Technical Note – LLFA Comments

Land West of Marlborough Road, Royal Wootton Bassett

Written on behalf of Miller Homes South West

Document / Report Number	RACE/ MHSW / RWB / TN001
---------------------------------	---------------------------------

Title:
DRAINAGE STRATEGY PLAN

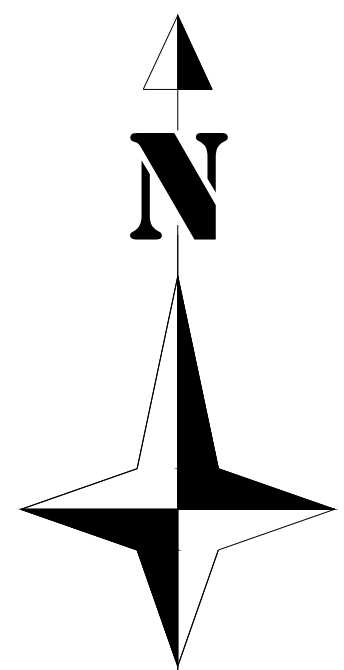
A drainage layout plan has been submitted as part of this application; however, no supporting technical information has been provided, such as hydraulic calculations, modelling outputs, detailed attenuation design, or evidence to demonstrate the performance of the proposed drainage system. Consequently, the submission does not provide the necessary information to demonstrate a safe & feasible drainage strategy compliant with Wiltshire Council requirements, NPPF, PPG and the National Standards for SuDS.

- The applicant is required to provide a clear demonstration of whether the proposed drainage strategy delivers betterment over the current site conditions. In particular, the design should demonstrate a minimum 30% betterment against the greenfield runoff rates for the 1 in 1 year, 1 in 30 year and 1 in 100 year plus climate change events. As the submitted drainage strategy states that the impermeable areas used within the design are indicative, confirmation is required that the proposed attenuation volumes, discharge controls and drainage infrastructure remain suitable based on the final impermeable extents.

Hydraulic calculations using FEH-22 data for the 1 in 1, 30 and 100 + 45% events are contained in **Appendix C** together with a copy of the Drainage Strategy Plan in **Appendix B**. These calculations demonstrate that the attenuation basins and associated cellular storage (Network 2 only) restrict the surface water flows to the required maximum discharge rates. The calculations also allow for a surcharged outfall within the design.
